Design Note

Project Begbroke Innovation District
 Subject EA Responses to Flood Risk Comments
 Project no 052188
 Date 21 June 2024

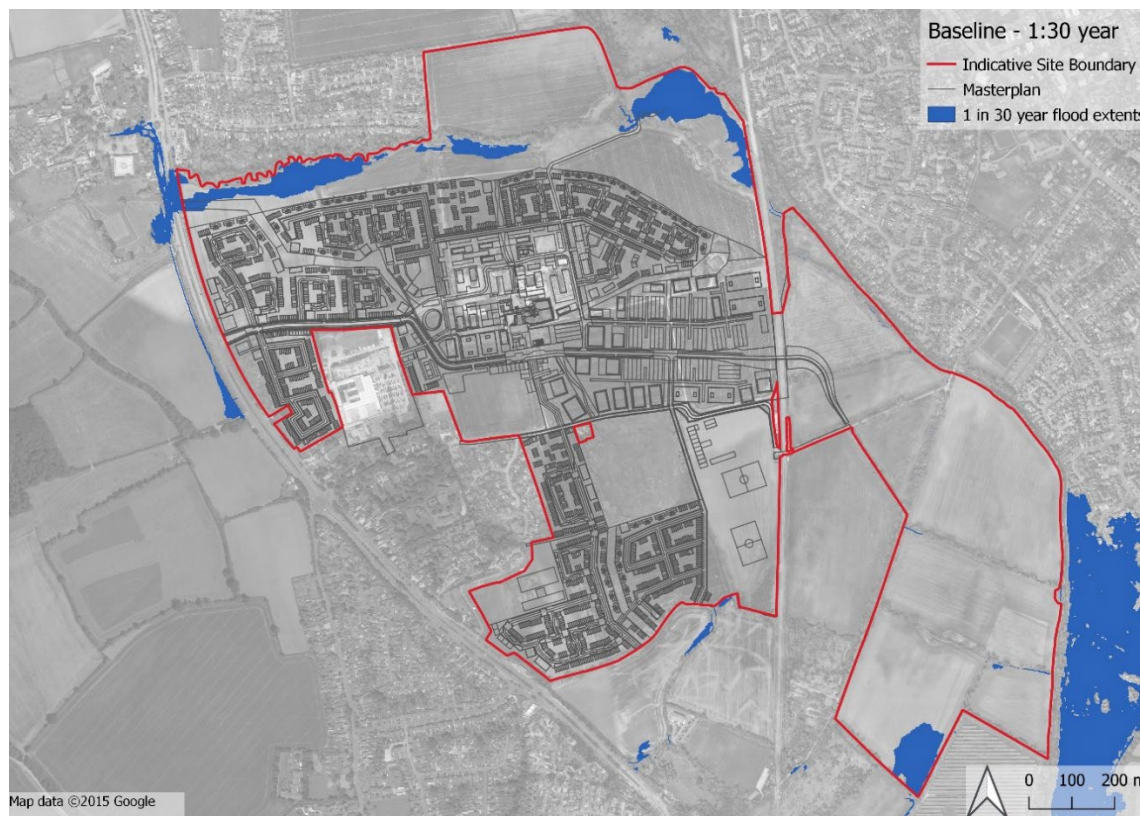
Item no.	Objection's/Comments	Responses and rectifications
2.4	<p>However, the hydraulic model still has several outstanding issues. The most significant of these are:</p> <ul style="list-style-type: none"> There has been no comparison of modelled outputs against the Historic Flood Map which does highlight areas of past flooding within the 2D model domain. 	<p>Figure 8 of the original FRA shows the flood mapping of historic flood events. This demonstrates there to be no historic flood events recorded within the proposed area for development. A few polygons of historic flood events are identified east of the railway line which generally align with where flooding is seen in the hydraulic modelling.</p> <p>An image overlaying the historic flood events mapping over the hydraulic modelling outputs is provided for clarity (see below and <i>Historic Flood Events with Baseline Mapping.jpeg</i>).</p>  <p>© Environment Agency copyright and/or database right 2021. All rights reserved. Map data ©2015 Google</p>
